**Record of Decision**  
**Utica City Dump**  
**Utica (C), Oneida County, New York**  
**Site No. 6-33-015**

**August 2003**

# **DECLARATION STATEMENT - RECORD OF DECISION**

**FIGURE 6**  
**ALTERNATIVE 4A**  
**1972 CAP**  
**UTCA CITY DUMP RI/F/S**

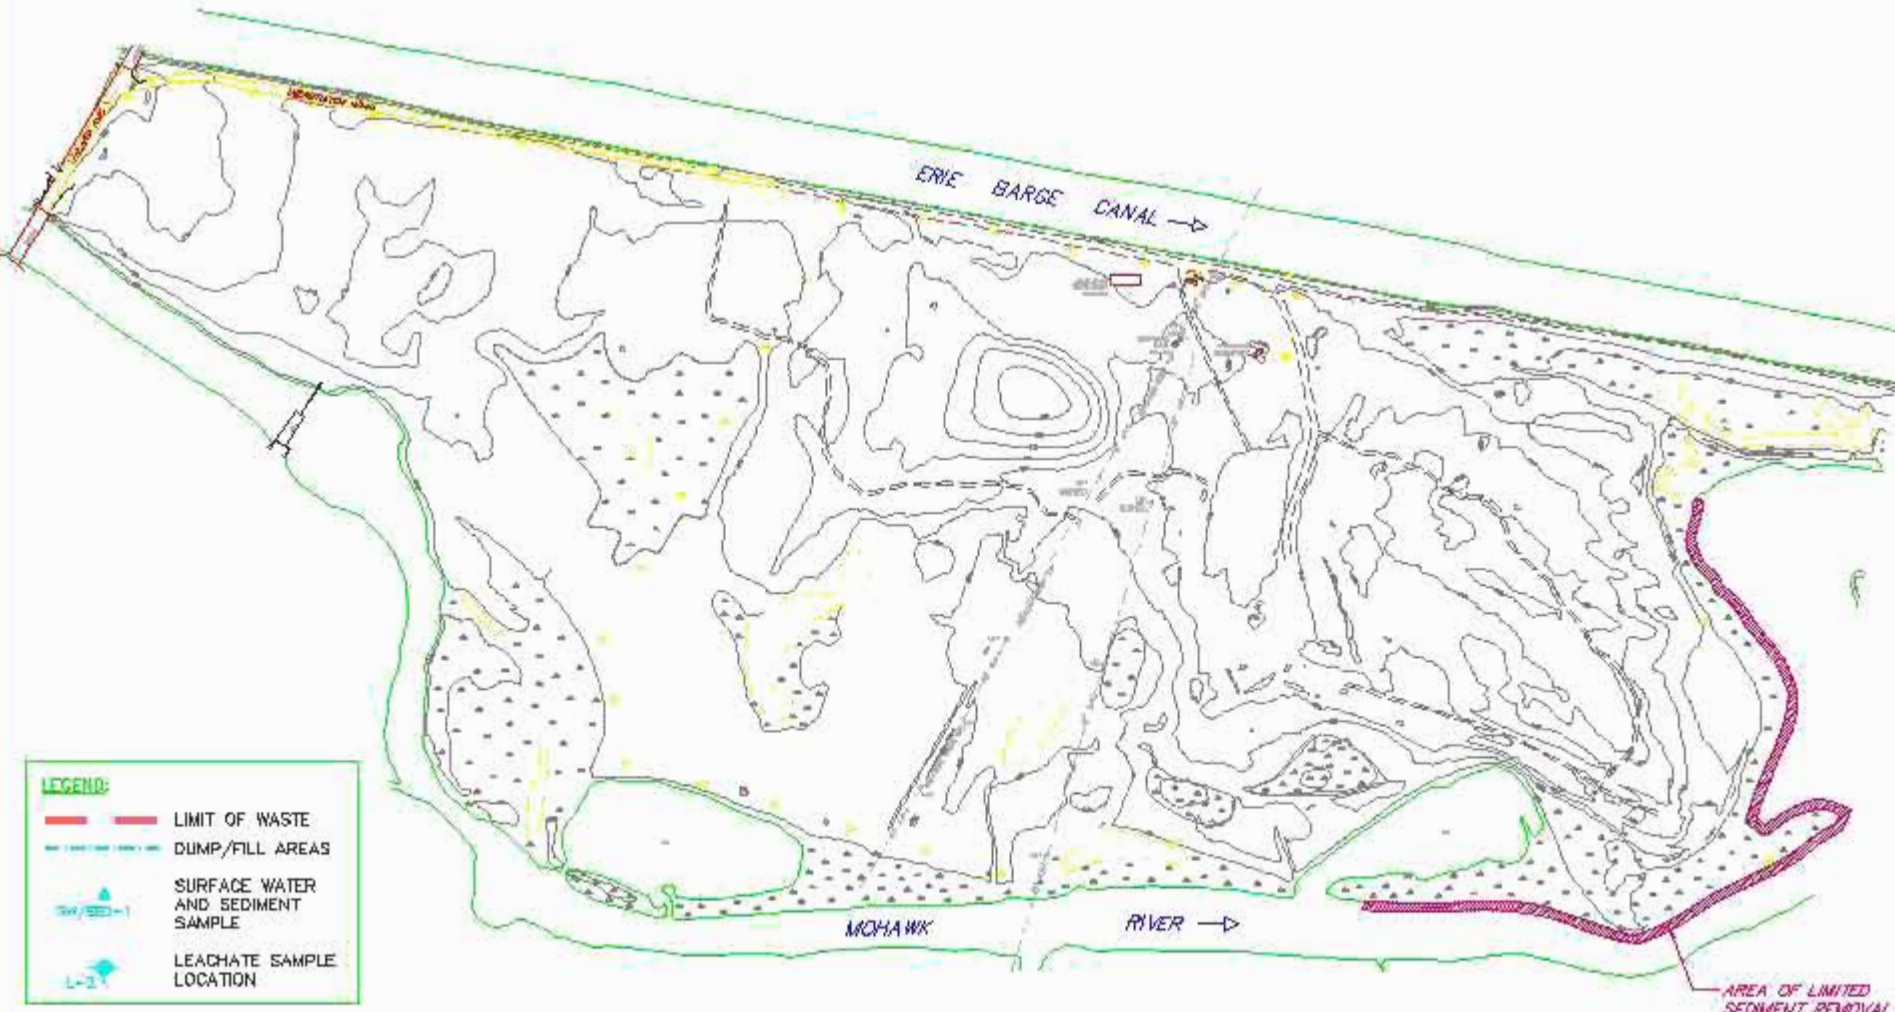
**Comment OC-2:** The OCSD is in the process of identifying and eliminating excessive flow throughout its sewer system. We expect that the Utica City Dump site, which is located between the Mohawk River and Barge Canal, would generate much greater than the OCSD's 10,000 GPD maximum acceptance guideline.

**Comment U-4:** I am concerned the DEC will come back at a later date and require a more extensive and expensive leachate collection system. Of equal or greater importance, the method of leachate treatment in the PRAP is not feasible according to the Commissioner of the Oneida County Department of Water Quality and Water Pollution Control.

Response: In light of the above comments, and concerns from the City of Utica, an impermeable Part 360 landfill cap has been selected as the final remedy and a leachate collection trench will not be needed at this time. Therefore, there will be no collected leachate pumped to the Water Pollution Control Plant.

Response: In light of the above comments, and concerns from the Oneida County Department of Water Quality and Water Pollution Control, the remedy was revised to an impermeable Part 360 landfill cap as a final remedy and a leachate collection trench will not be needed at this time. Therefore, there will be no collected leachate pumped to the Water Pollution Control Plant.
